EYECARE MEDICAL GROUP
PHASE 2 ADDITION AND RENOVATION
ADDENDUM NO. 3
JULY 23, 2013

This Addendum modifies, amends and supplements designated parts of the Contract Documents, Project Manual and Drawings for E.M.G. - Phase 2 - Addition and Renovation and is hereby made a part thereof by reference and shall be as binding as though inserted in its entirety in the locations specified herein. It shall be the responsibility of the Contractor to notify all Subcontractors and Suppliers he proposes to use for the various parts of the work of any changes or modifications contained in this Addendum.

SHEET: C-2.0

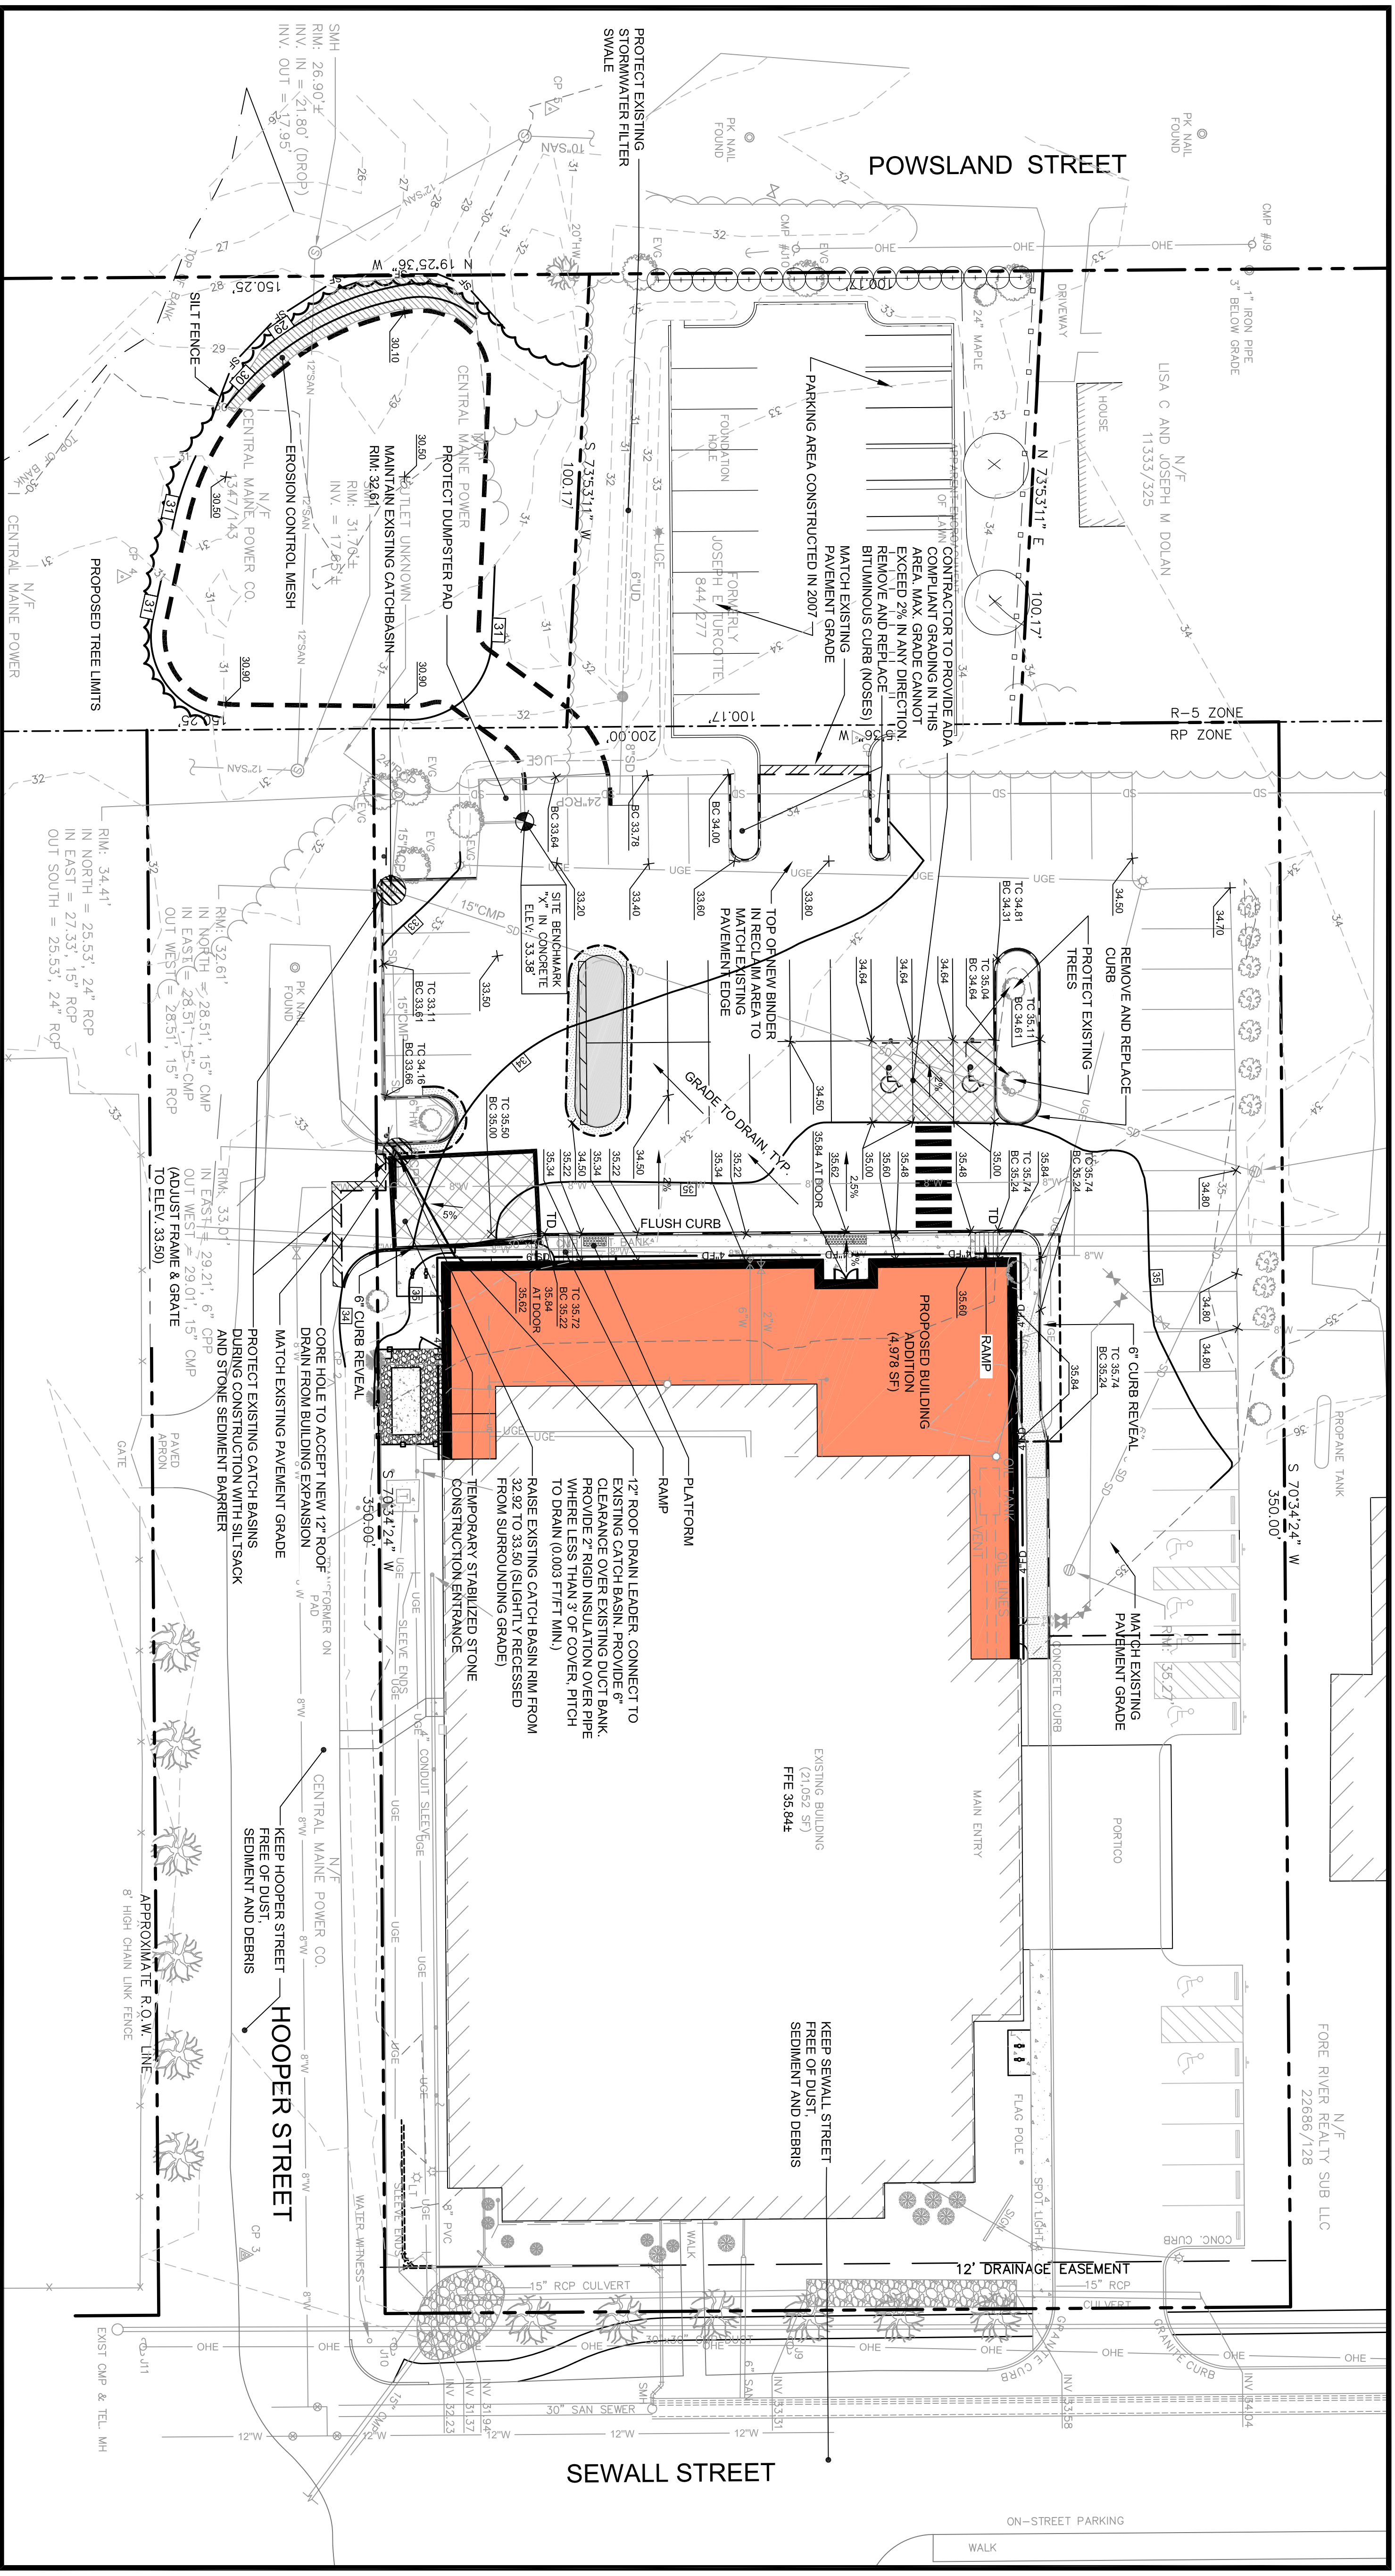
- I. Drawing C-2.0 – Site Layout Plan:
 - a. The site plan has been revised such that no proposed work is within the paper street portion of Hooper Street. The proposed pavement within this area and curbed island have been removed.
 - b. The alignment of the proposed driveway has been revised to stay away from the paper street portion of Hooper Street. The proposed sidewalk and bike rack area has been revised to accommodate the driveway shift. NOTE: a minimum sidewalk width of 3'-0" shall be maintained adjacent to the south west corner of

the proposed building addition.

c. The existing curb that runs parallel to the paper street portion of Hooper Street shall be removed and replaced to match revised grades along this edge of the site.

d. A thin chevron/striped island is proposed along the southerly edge of the curbed island scheduled for removal to create an additional two parking spaces.

e. The northerly side of the existing 20 space parking area (constructed 2007) shall be restriped to create eleven (11) parking compact parking spaces 8 feet wide by 19 feet long. The existing striping shall be eradicated.

PROJECT: **DELCUCA-HOFFMAN ASSOCIATES, INC.**
 2 - ADDITION & RENOVATION
 SHEET TITLE: **GRADING, DRAINAGE AND EROSION CONTROL PLAN**
 CLIENT: **PDT ARCHITECTS**

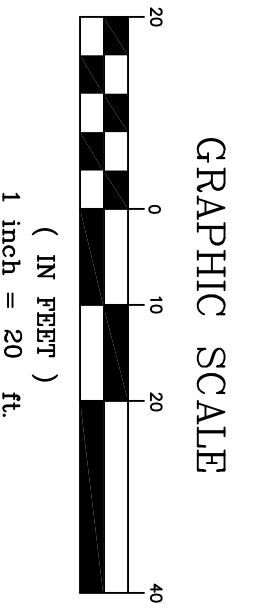
2. Drawing C-3.0 – Grading and Drainage and Erosion Control Plan:

a. The grading adjacent to the site driveway has been revised to avoid disturbance to the paper street portion of Hooper Street.

b. **Not shown of plan:** The three existing catch basins within the paved area of the site shall be fitted with a Fabco Industries “Stormsok” filter bag inserts fitted with an oil absorbent booms.

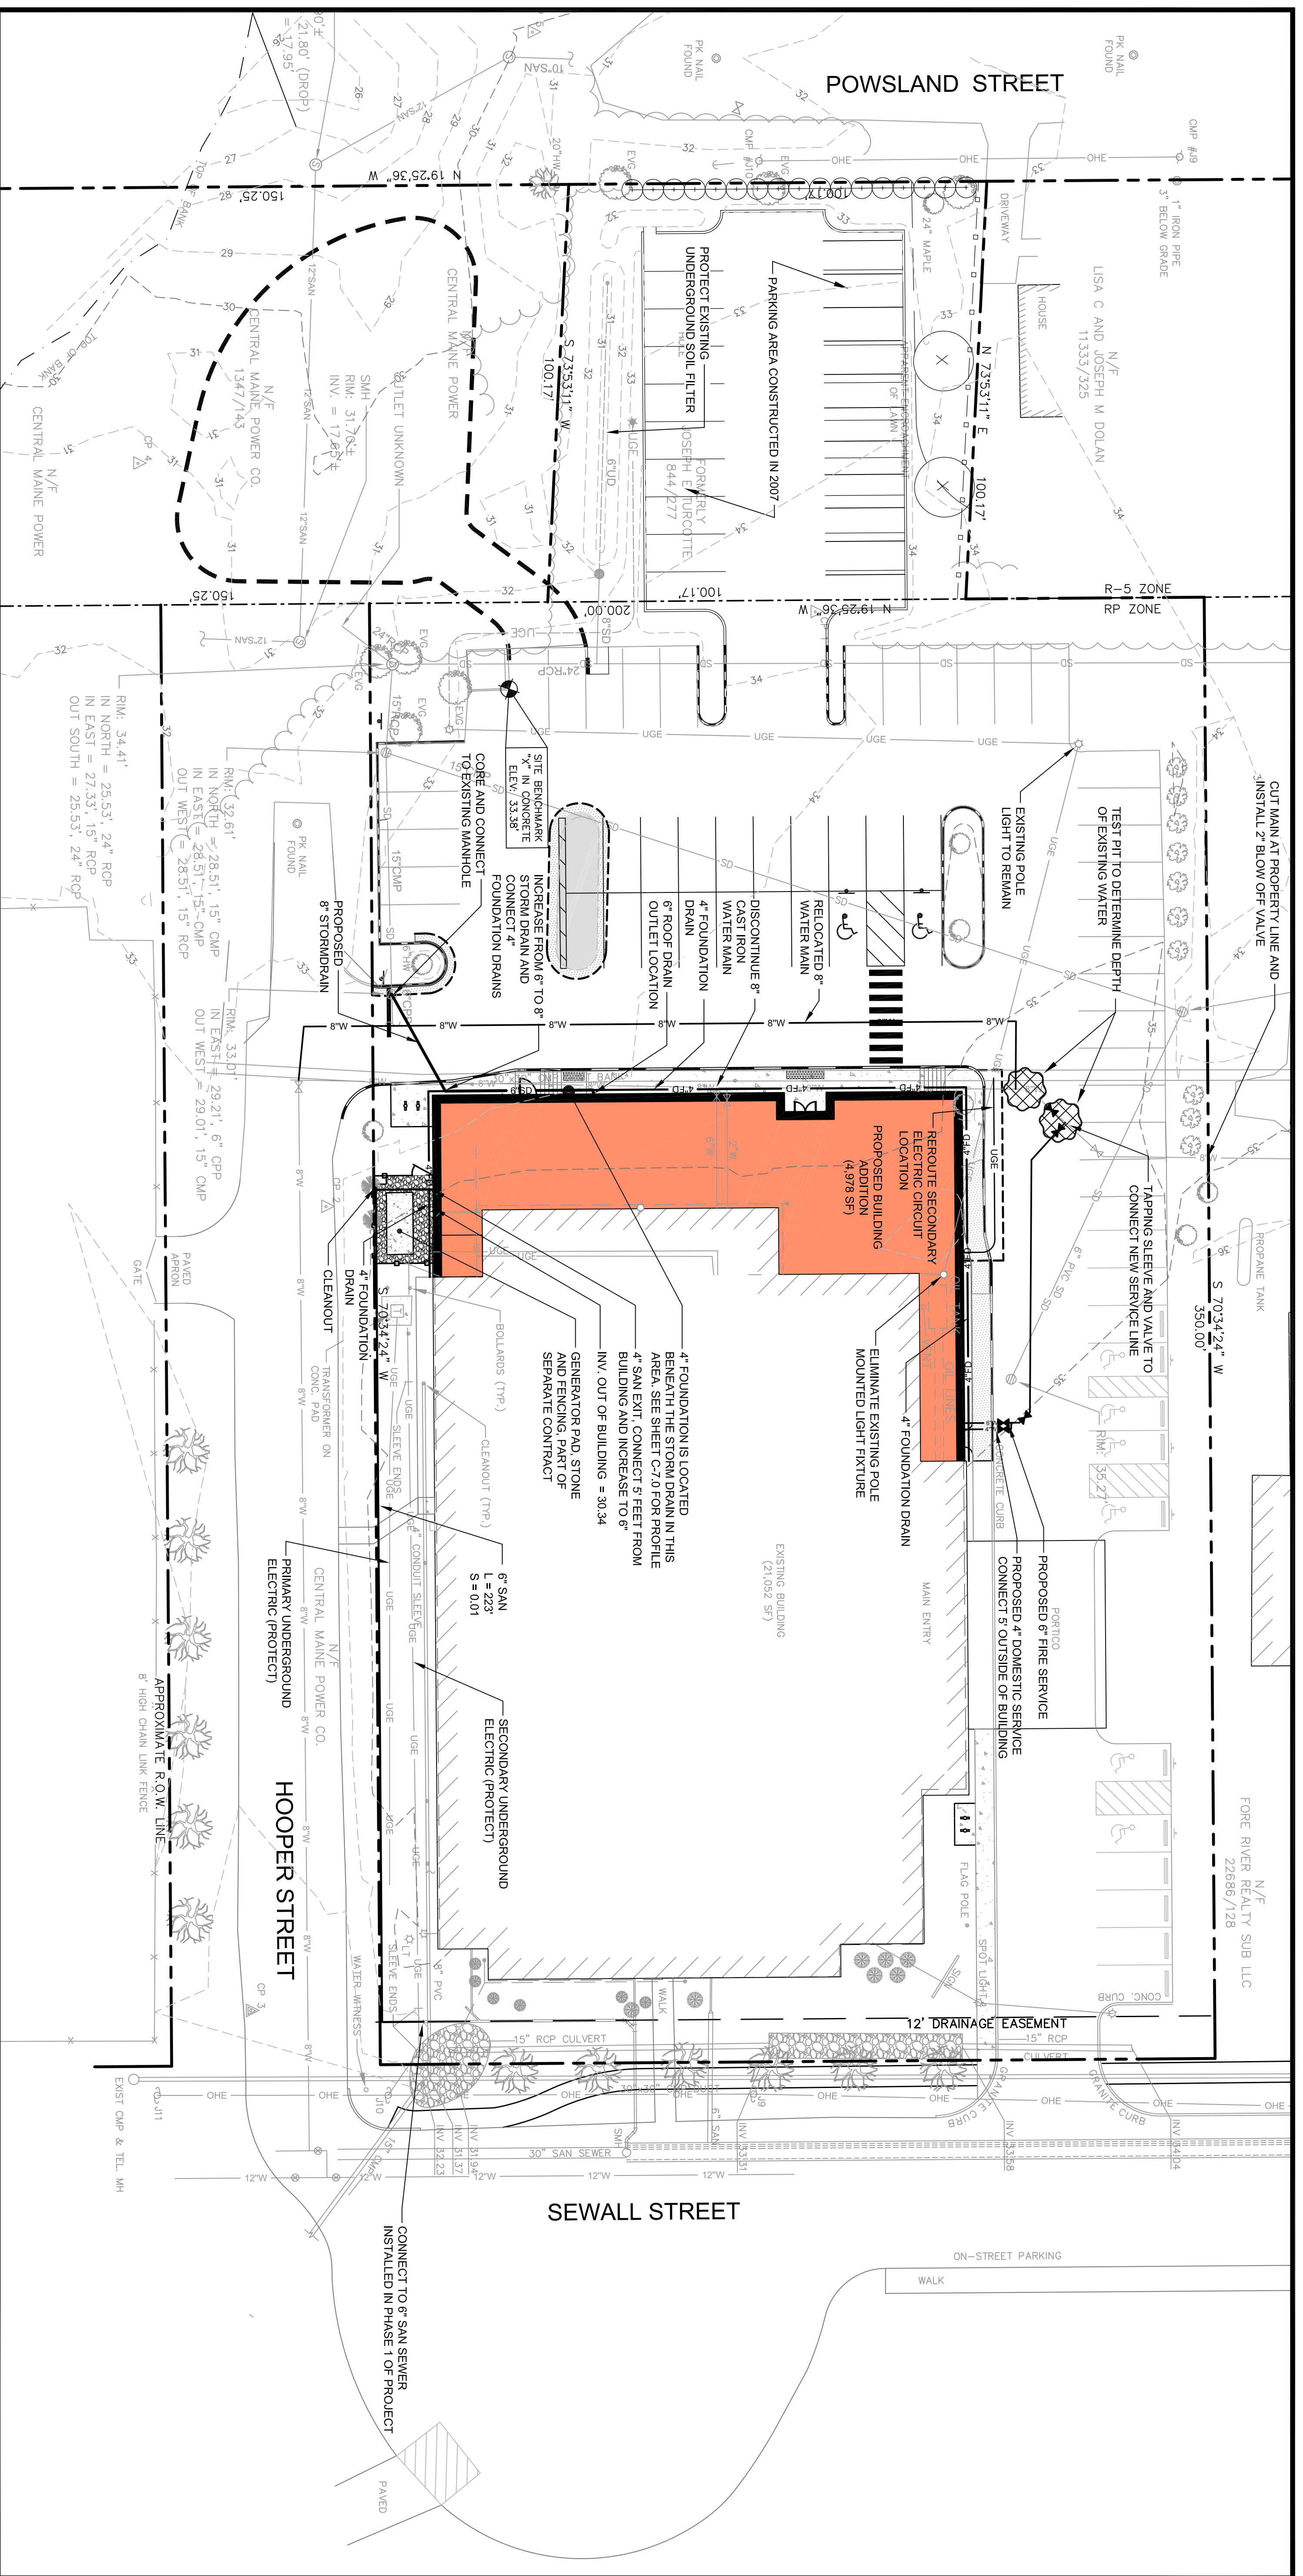
3. Drawing C-4.0 – Utility Plan:

a. To avoid work within the paper street portion of Hooper Street, the sanitary sewer service (6” dia) has been re-routed to connect to the existing 6” sewer stub (provided in Phase I) near Sewall Street.

b. To avoid work within the paper street portion of Hooper Street the 8” water main and services have been relocated as shown on C-4.0. This routing recreates the existing “Davis Street” water main loop.

SHEET
 SKA-5

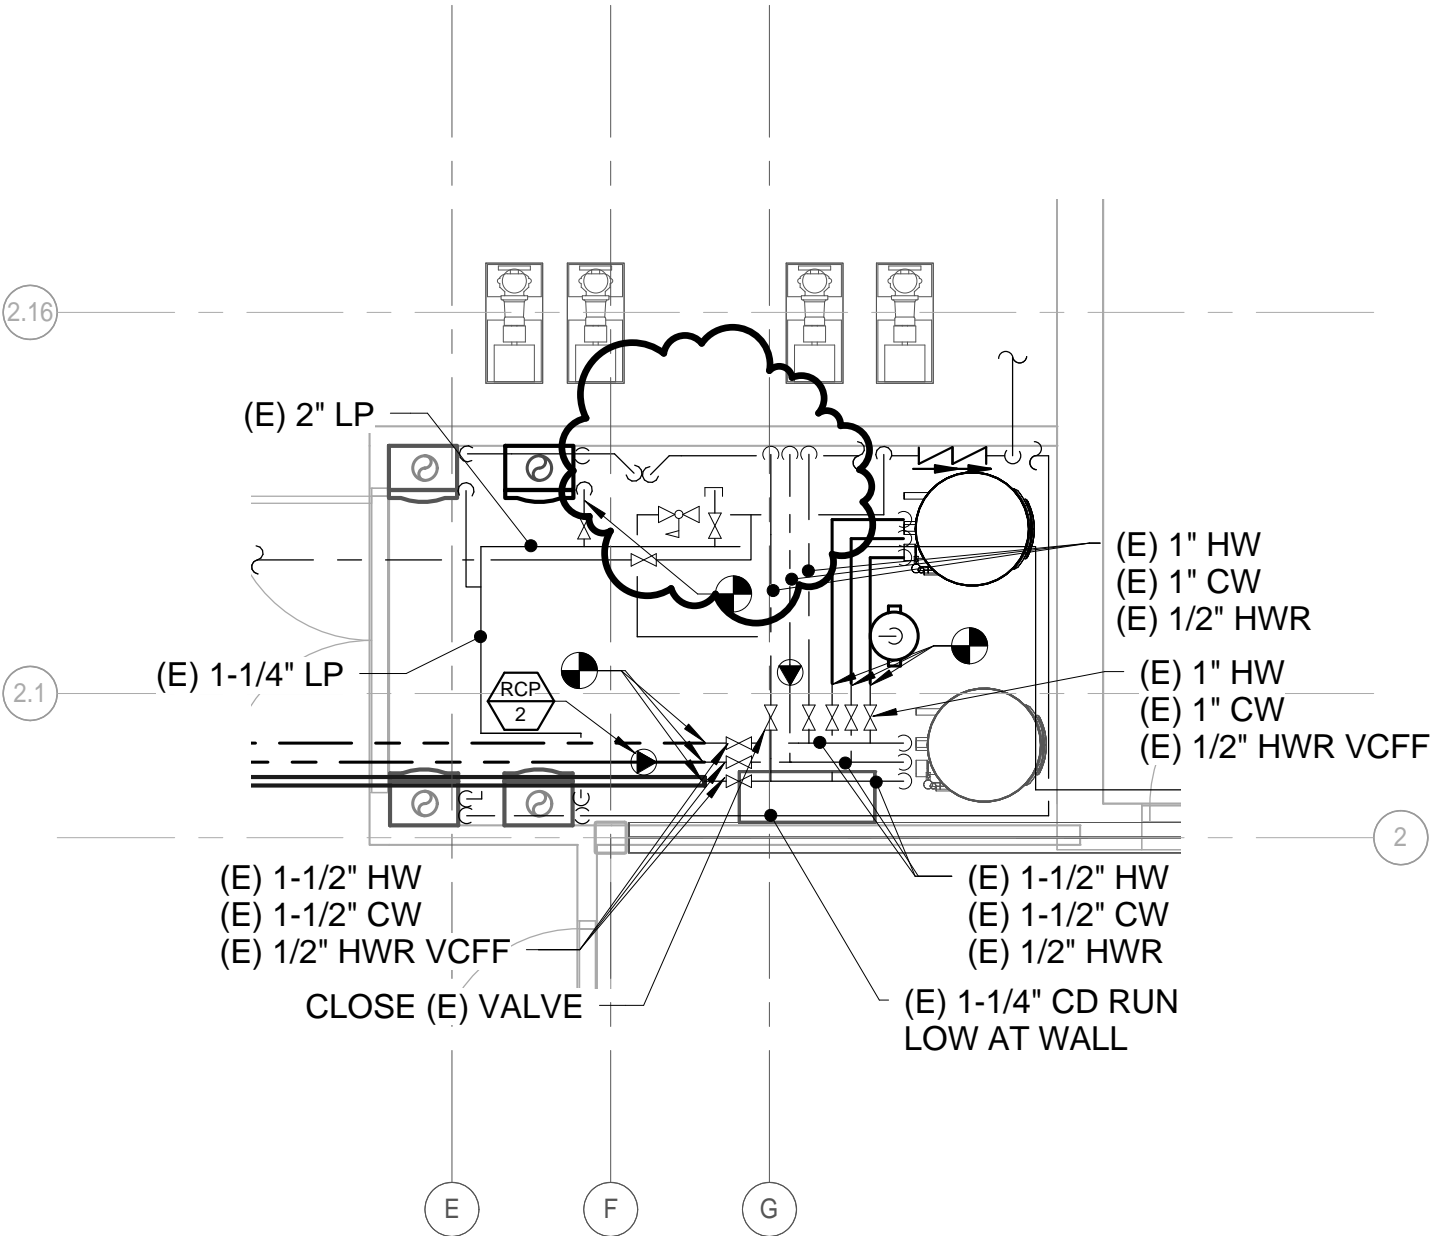
1. Sheet A002 - DELETE text reading "VAPOR RETARDER" shown on the Single-Ply Membrane Roofing System on Concrete Slab.
2. Sheet A202 – DELETE cabinets in Post Op BI09 (6 stations), as shown on elevations BI and CI.
3. Sheet A501 – REPLACE detail D3 with the attached SKA-5.
4. Sheet A503 – REPLACE detail BI with the attached SKA-4, indicating a typical soldier course in the exterior walls (with the exception of the quoin corners).
5. Sheet A600 - CHANGE, Door and Frame Schedule, Door N^o AI17 (Gas Room) width to be 3'-6".
6. Sheet A600 – CHANGE aluminum storefront type W1 to be 3'-4" above floor finish, to align appropriately with brick coursing.

SHEET
SKP-3

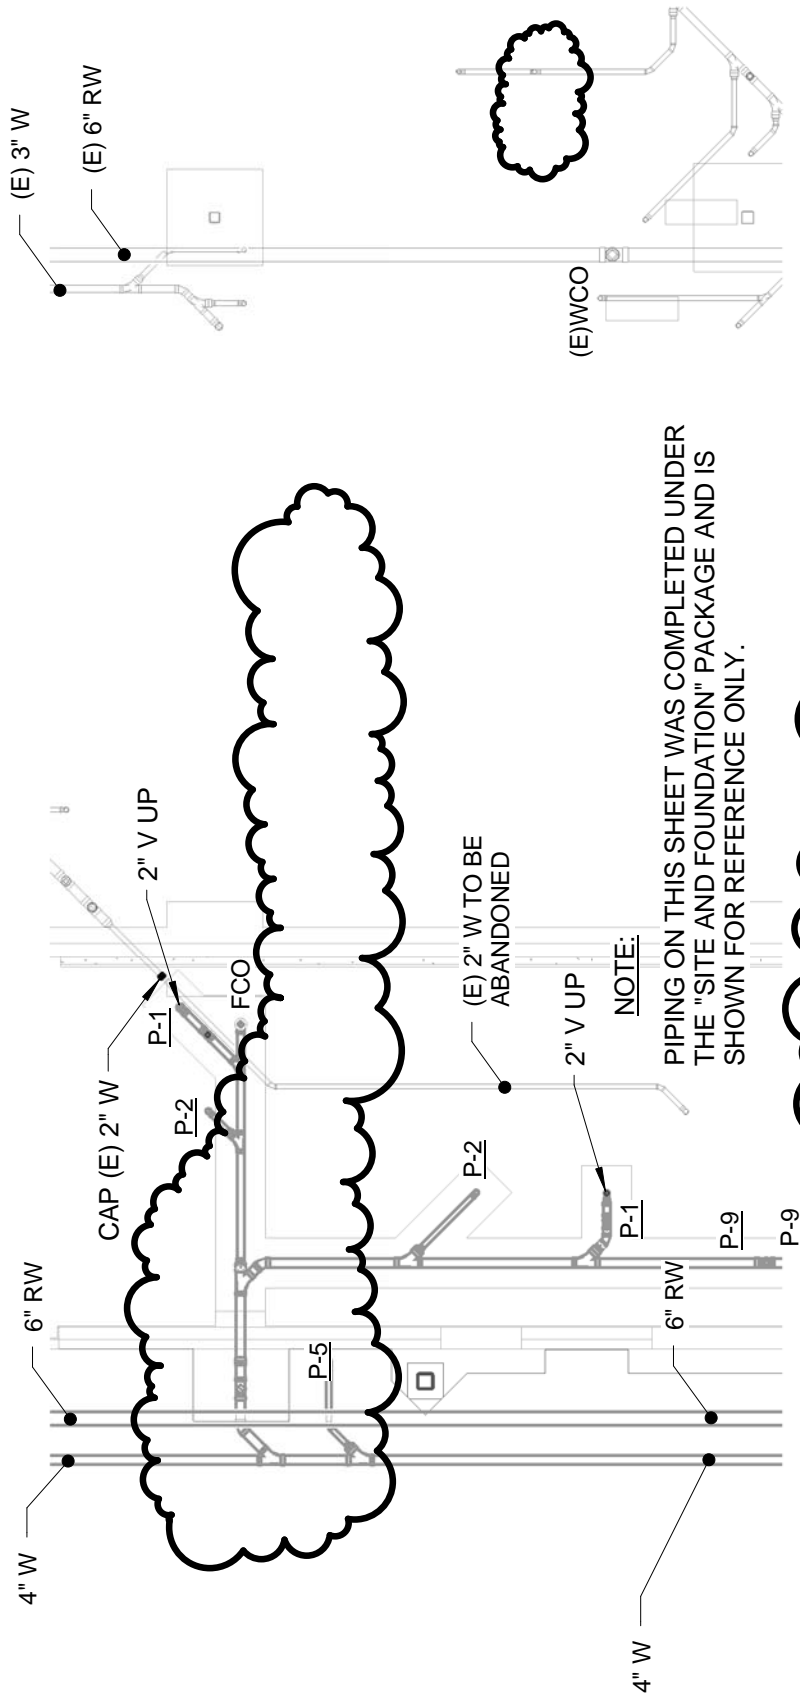
1. Sheet PL-400: **DELETE** reference to Boiler N^o5 as outlined in SKP-3, attached.
2. Sheet PL-100: Refer to SKP-5, attached for deleted key note N^o 3 and deleted note.
3. Sheet PL-102 Refer to SKP-6, attached for existing domestic piping completed under phase N^o1.
4. Sheet MH-101: Refer to SKM-1, attached for revisions to the Humidifier and Humidistat requirements for the OR's.
5. Sheet MH-400: **DELETE** the entire sheet. **ADD** in its place Sheet MH-400, with Revision N^o1, attached.
6. Sheet MH-600: **REVISE** the Pump schedule and **ADD** an Air Control Schedule as outlined on SKM-2, attached.
